ENGINEERING CHANGE NOTICE

Originator:	Bo Byoung Jeon	Date:	August 29, 2023	Document Number	ECN20230829-00
Phone No.	(416) 754-3322	Part Number	B10-029-266-032	Drawing Revision	Rev.17
Email Address:	bbjeon@edac.net				
Department	ENGINEERING

DVI-I RECEPTACLE R/ANGLE CONNECTOR
FOR DIGITAL-ANALOG INTERFACE
WITHOUT BOARDLOCKS

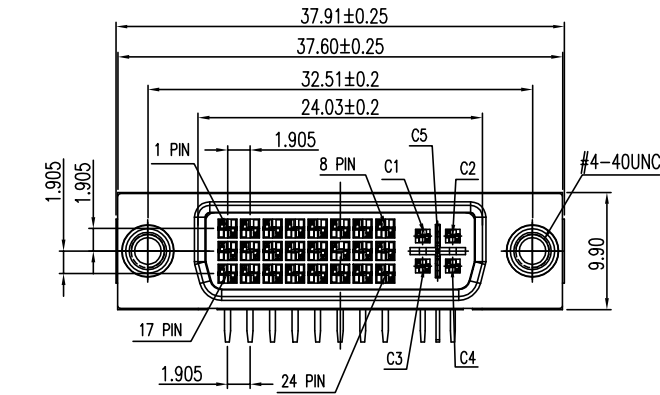
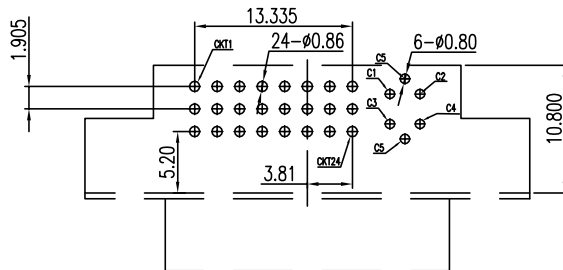
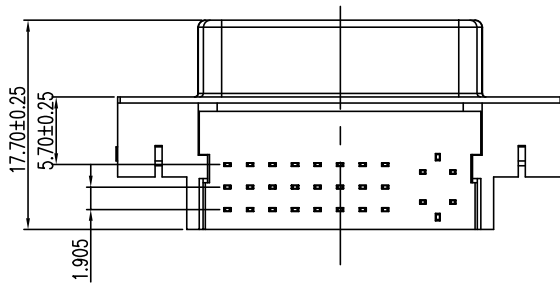
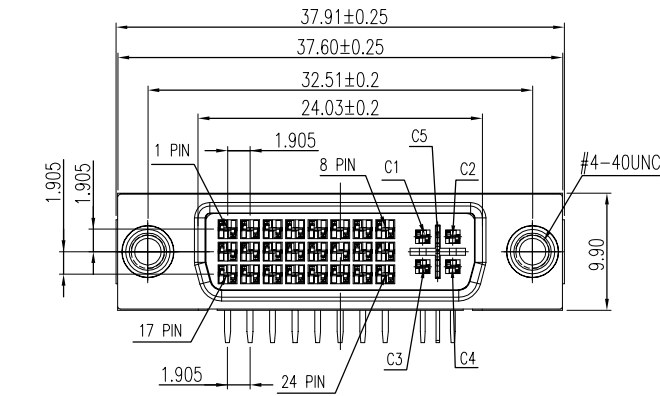
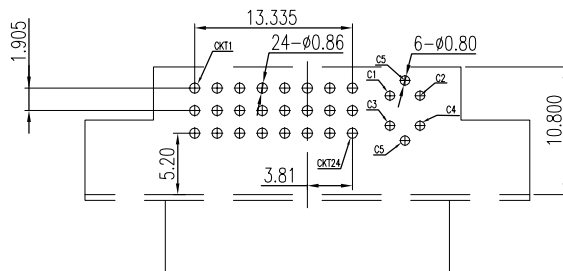
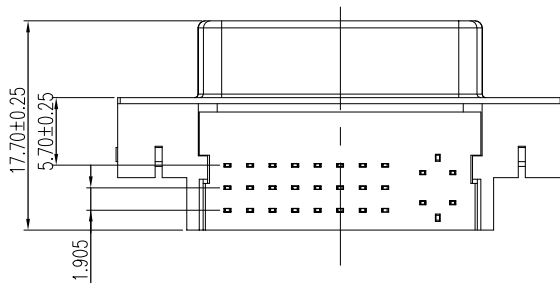
Material changes from LCP to PBT for productivity. There is ZERO impact on the functionality of the part because of this change.

Material changes from LCP to PBT

ORIGINAL	①
DIM. .683(17.35) WAS .679(17.14) F.BRIONES OCT.17/02	②
BOARDLOCK DETAIL CHANGED R.BLAKEY NOV.28/03	③
RE-DESIGN; RoHS STATEMENT ADDED. F.BRIONES NOV.23/05	④
NOTE 6 ADDED F.BRIONES DEC.16/05	⑤
THREADED RIVET ADDED F.BRIONES AUG. 11/06	⑥
INSULATOR UNDERCUT FOR RIVET ADDED R.BLAKEY JUN. 14/07	⑦
CURRENT RATING, CONTACT RESISTANCE, DWV AND INSULATION RESISTANCE WAS 5 AMPS, 30 MILLIOHMS, 1000 VAC AND 5000 MEGOHMS F.BRIONES OCT.29/07	⑧
HOLES LOCATIONS ADDED F.BRIONES JUN. 17/08	⑨
BOTTOM INSULATOR CHANGE F.BRIONES FEB. 17/09	⑩
DIM. 1.465 WAS 1.450 F.BRIONES NOV.01/11	⑪
DIM. .720(18.29) WAS .683(17.35) NEW TOOLING F.BRIONES OCT.15/12	⑫
UPDATE MATERIAL & ELECTRICAL CHARACTERISTICS R.STA.MONICA JAN.21/2013	⑬
NEW TOOLING F.BRIONES OCT.28/13	⑭
UPDATE DWG. P.M. FEB. 26/2020	⑮
BOARDLOCK REMOVED P.M. APR. 07/2020	⑯
PBT WAS LCP J.L. AUG. 29/2023	⑰

Housing:PBT, UL 94V-0, Color:Ivory.
 Latch:PBT, UL 94V-0, Color:Ivory.
 Terminal:Copper Alloy.
 Shell:SPCC.
 Rivet:Copper Alloy.

1. MATERIAL:
 - Housing:PBT, UL 94V-0, Color:Ivory.
 - Latch:PBT, UL 94V-0, Color:Ivory.
 - Terminal:Copper Alloy.
 - Shell:SPCC.
 - Rivet:Copper Alloy.
2. FINISH:
 - Terminal:Gold Plated over Nickel at Contact Area.
 - Tin Plated over Nickel at Solder Area.
 - Shell:Nickel Plated.
 - Rivet:Nickel Plated.
3. This Product is RoHs Compliance Product.
